EH-PLANS-25-0

EnvHealth/Environmental Health/Plan Check/Application

SFD/ CONSTRUCT (2) STORY 41' X 38' GARAGE WITH SECOND FLOOR STORAGE TO INCLUDE HALF BATH - COVERED WALKWAY TO CONNECT TO HOUSE, 2 STORY, Slab on Grade, 1R, 0FB, 1HB, 0FP, OTHER STRUCTURE = Detached Garage, 0BR, PORCH/DECK = N/A, ENERGY METHOD = N/A,

APPLICATION FOR WAIVER

SITE INSPECTION SHEET

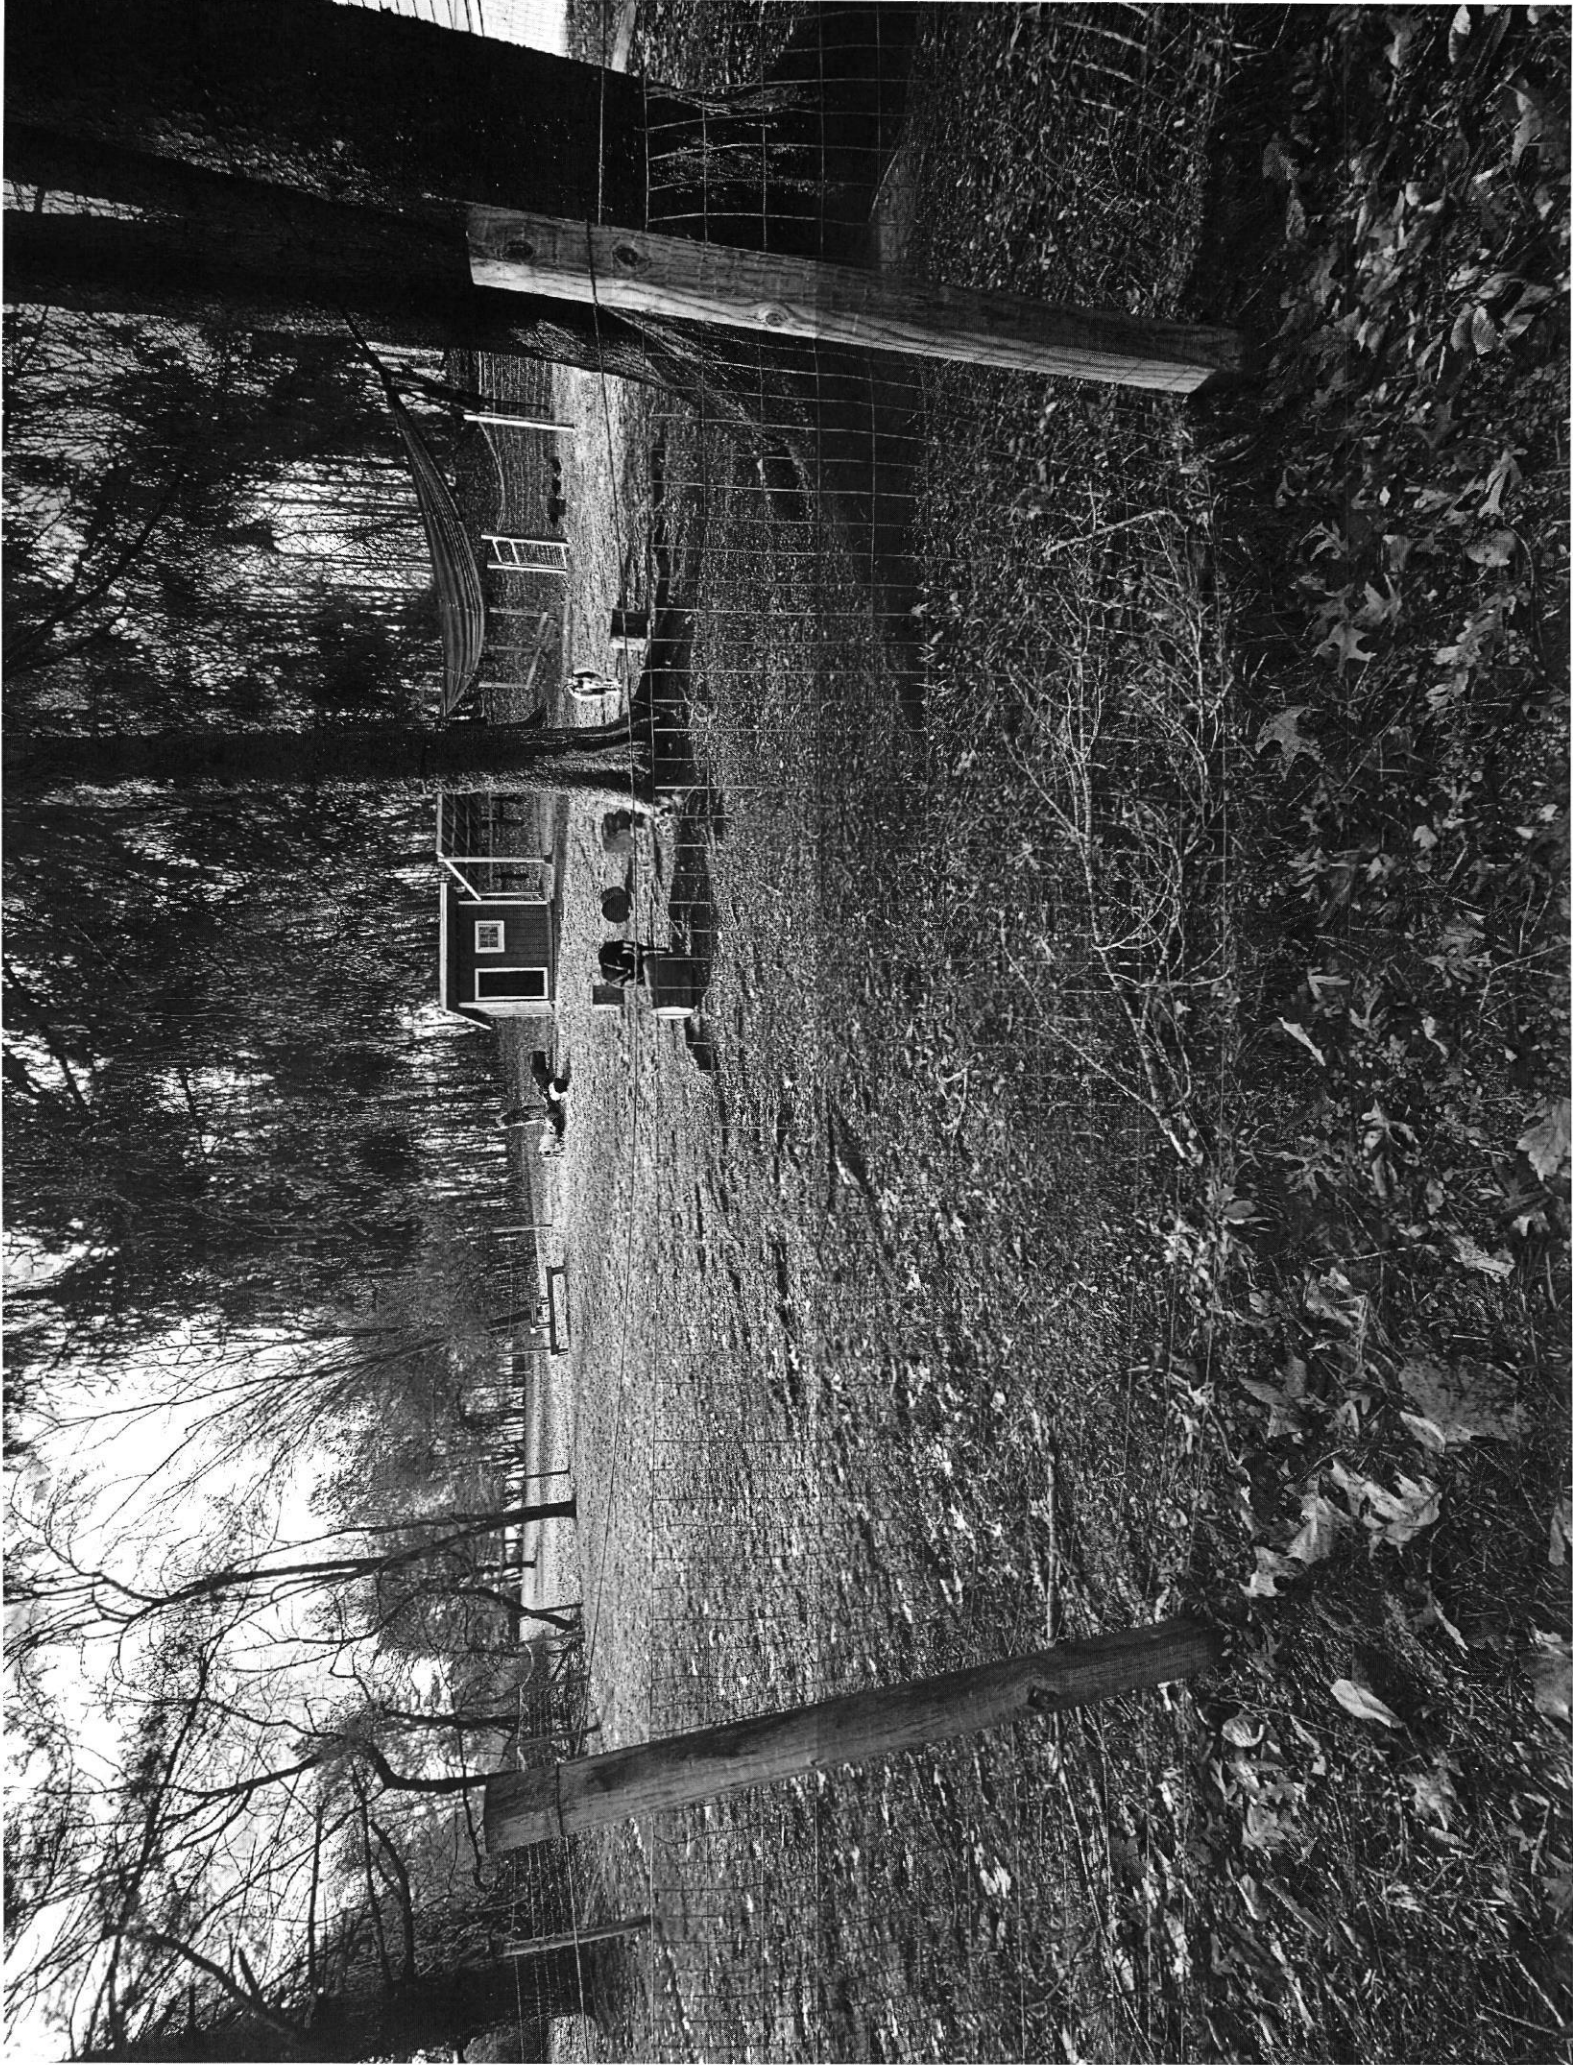
COMMENTS: No signs of hydraulic failure and
well okay. Driveway proposed over
previously tested area
